## Vogle ILT22 NRC Post-Exam Comment

### Simulator JPM 'f'

## FACILITY POST-EXAMINATION COMMENTS AND NRC RESOLUTIONS

JPM f – Discontinue Parallel Operation by Removing DG1A from Bus 1AA02

##### 1. Diesel Generator in Parallel Operation:

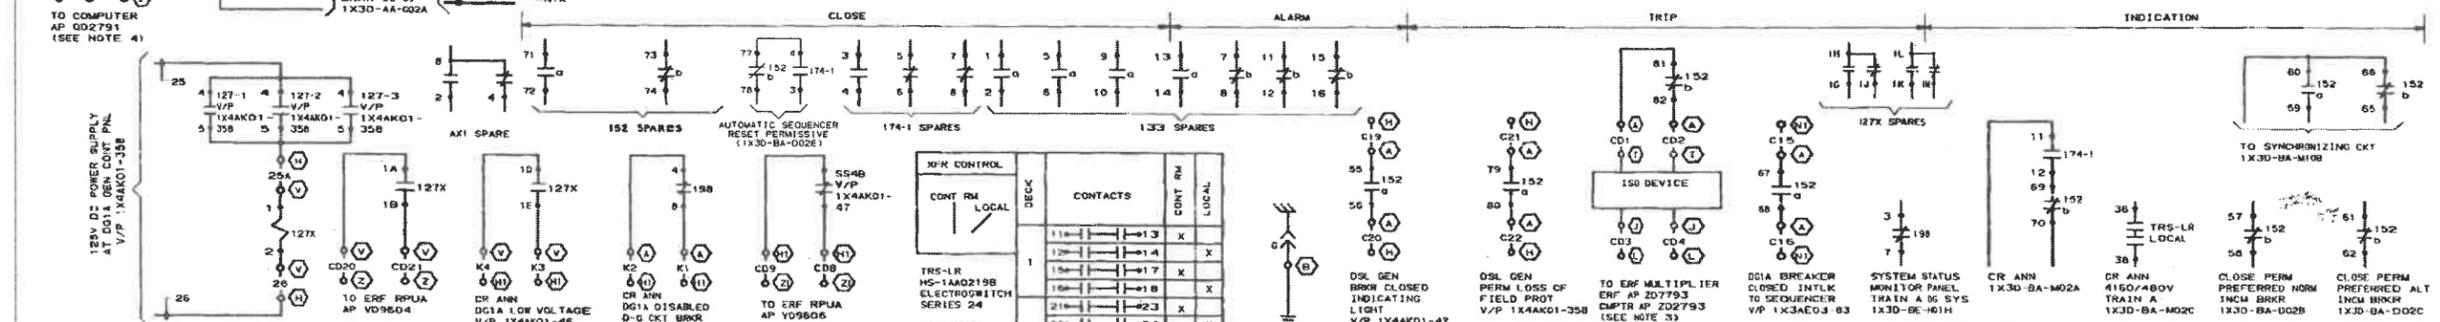
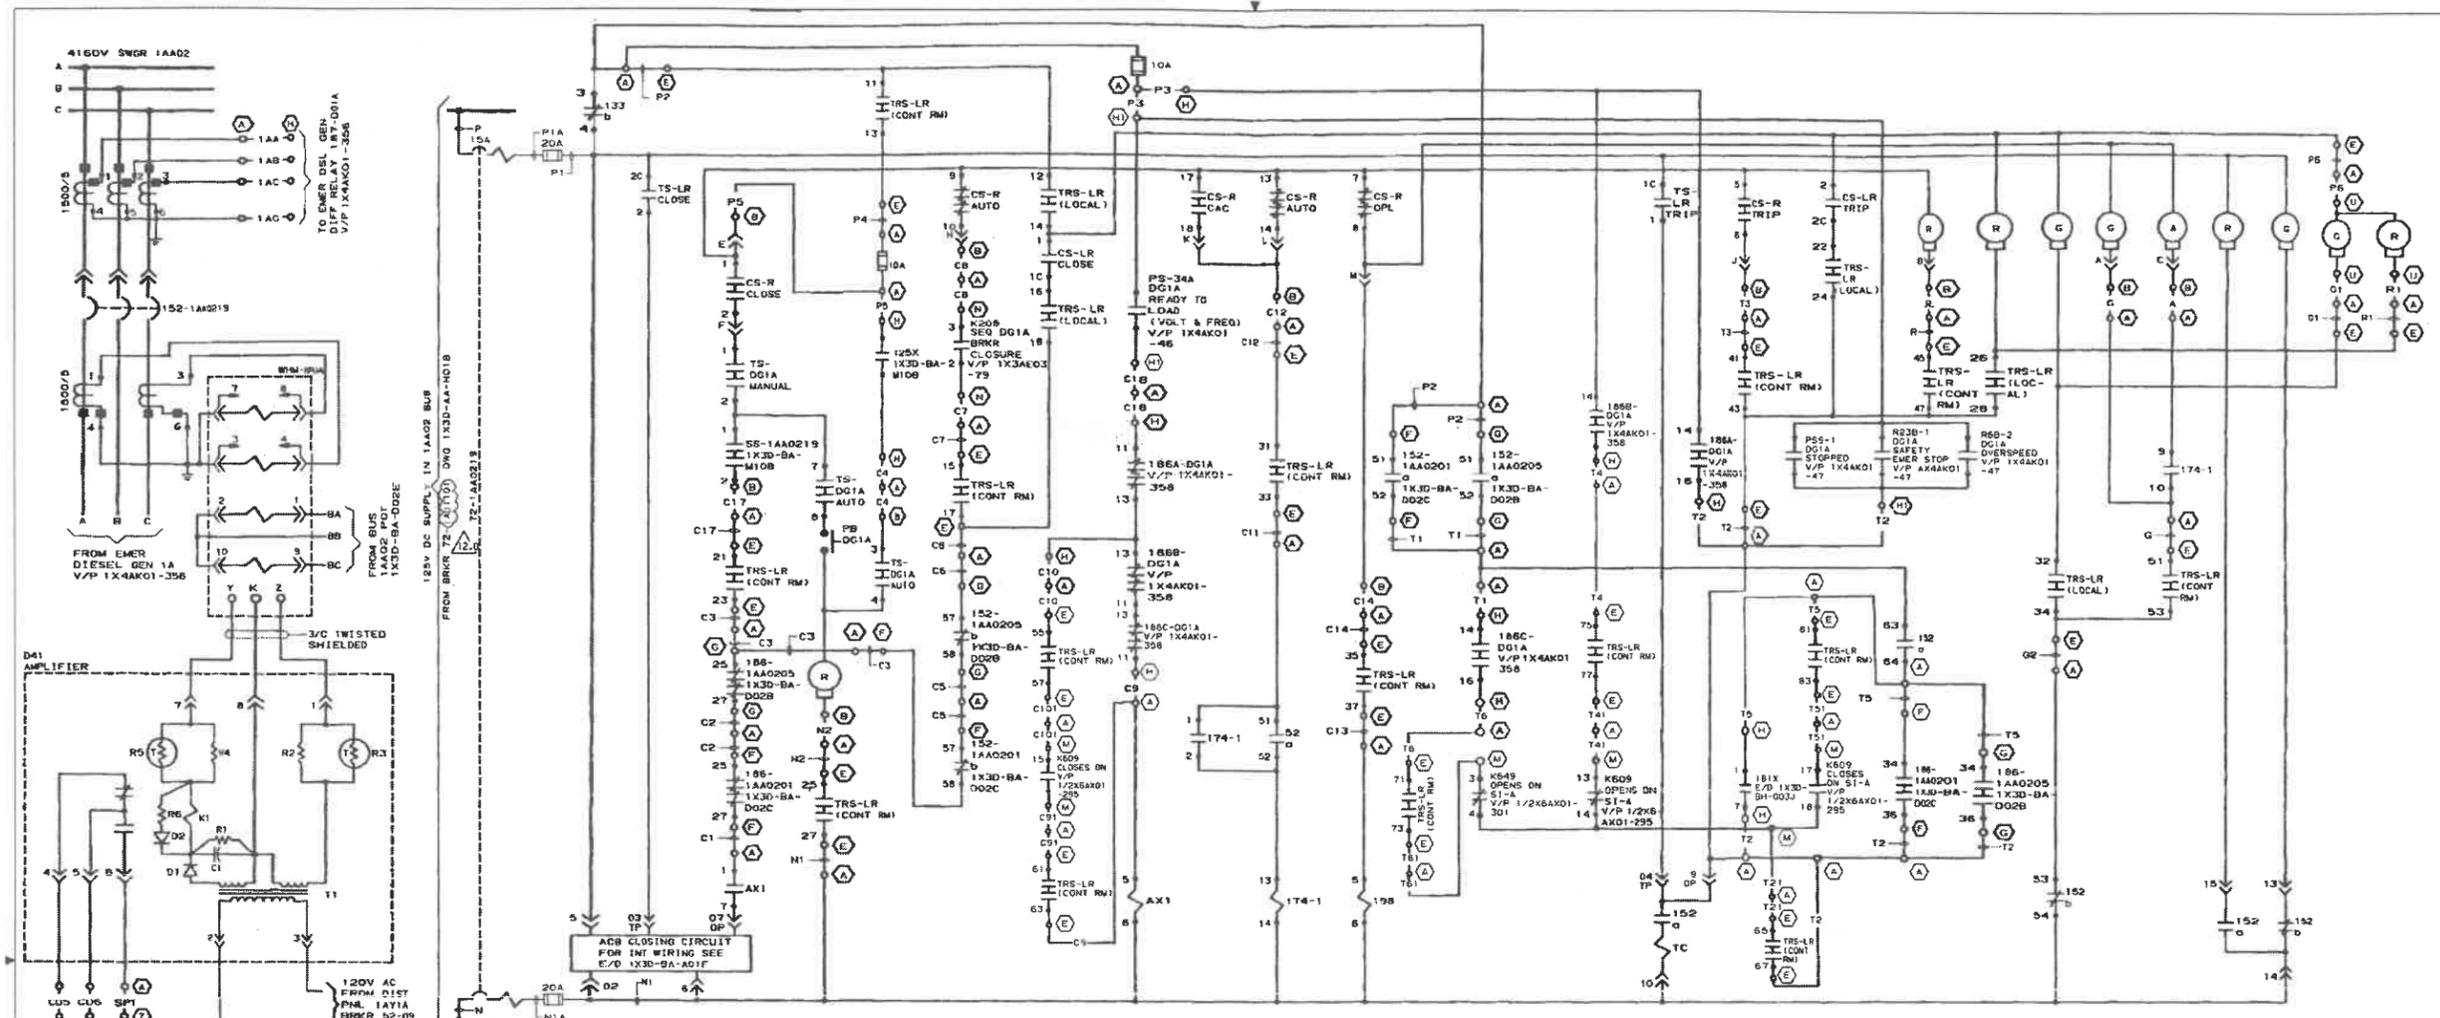
JPM 'f', Step 7 (from 17035-1), is marked as a *critical step* and reads as follows:

- a. Check bus frequency. If less than or equal to 59.5 Hz, ensure Diesel Generator Breaker, 1AA02-19, has tripped.

Standard: Applicant checks the DG1A Frequency Meter or the 1AA02 Frequency Meter on the QEAB and determines that frequency is less than 59.5 Hz. The applicant then opens 1AA02-19, DG1A Output, by placing 1HS-1AA0219 to TRIP (this may have been done earlier during JPM Step 5).

Per NUREG-1021, "Operator Licensing Examination Standards for Power Reactors," Appendix 'C', page C3, a *critical step* is a step "that the examinee must perform correctly (i.e., accurately, in the proper sequence, and at the proper time) to accomplish the task standard." Based on this definition, JPM Step 7 should NOT be a critical step because if JPM Step 7 is NOT performed, then the task standard would still be met if the applicant successfully stops DG1A (normal or emergency stop) during the performance of the JPM. If the applicant performs a normal or emergency stop of DG1A in the following procedure (JPM) step, the DG1A output breaker will automatically open (see elementary diagram 1X3D-BA-D02D and associated enlarged region included). Stopping DG1A is a *critical step* because it must be performed to accomplish the task standard, which requires DG1A to be stopped with its output breaker open. The DG1A output breaker is designed to automatically open when a Normal, Emergency, or Overspeed stop of DG1A occurs, so there is no negative consequence to this operating sequence. Therefore, the facility recommends removing the *critical step* designation from JPM Step 7.

The licensee's recommendation was not accepted. The answer key to JPM f has not been revised.

The NRC disagrees with the licensee's contention that step 7 was not critical. By not opening the diesel output breaker prior to tripping the machine, the applicant unnecessarily tested the automatic interlock that opened the breaker. If this interlock had failed, the diesel would have shut down still connected to the grid potentially damaging the safety related piece of equipment. This possibility of damage made the step safety significant and therefore the step remained critical.

ELEMENTARY DIAGRAM  
ELECTRICAL SYSTEM  
4160V INCM BRK 152-1AA0219  
FROM EMERGENCY DIESEL GEN. 1A

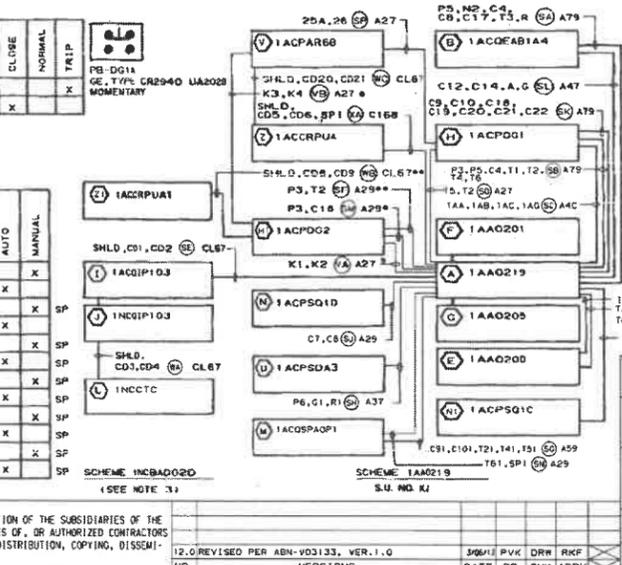
If the applicant performed a normal or emergency stop of DG1 A in the following procedure (JPM) step, the DG1 A output breaker would automatically open. Stopping DG1A continued to be a critical step because it must have been performed to accomplish the task standard, which required DG1A to be stopped with its output breaker open. The DG1A output breaker was designed to automatically open when a Normal, Emergency, or Overspeed stop of DG1 A occurs, so there was no negative consequence to this operating sequence. Therefore, the facility recommended removing the critical step designation from this JPM step.
